**FINAL
CONTRACT-SPECIFIC SAMPLING AND ANALYSIS PLAN
FOR SENECA ARMY DEPOT ACTIVITY PBC II**

REMEDIAL ACTIONS AT SEVEN SITES (SEADS-4, -11, -16, -17, -38, -70, AND -121C)

**SENECA ARMY DEPOT ACTIVITY
ROMULUS, NEW YORK**

Response to Comments

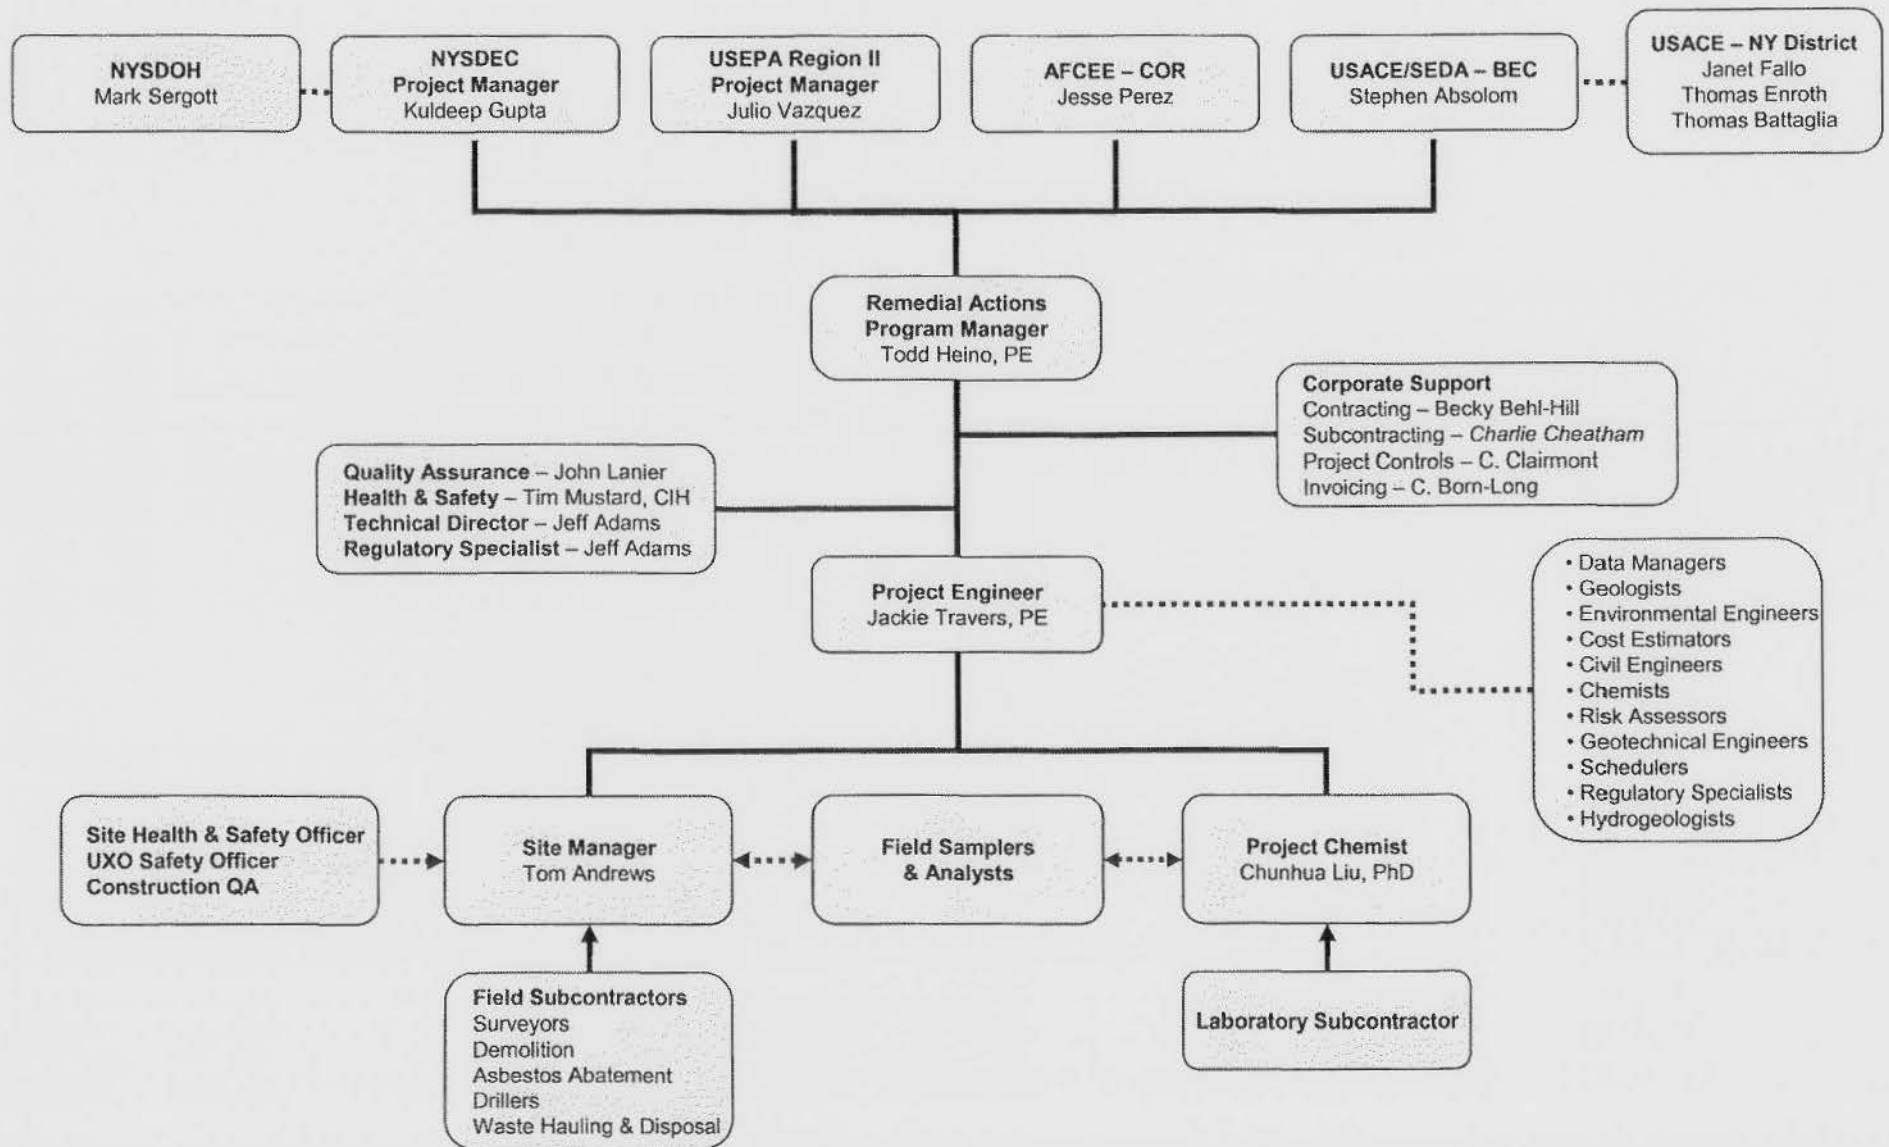
Comment 1: I found Areas of Concern (AOCs) on Figure 2 that are not explained within the text, for instance, buildings 2110, 336, S-331, SEAD-70. In addition, I could not find building S-01 on figure 2, even though it is listed within the text.

Response 1: Agreed. Figure 2 has been revised to be consistent with the text. Discussion of SEAD-70 has been included in the text as Section 2.5. It should be noted that building demolition will be presented in detail in a separate document and therefore is no longer included in this document.
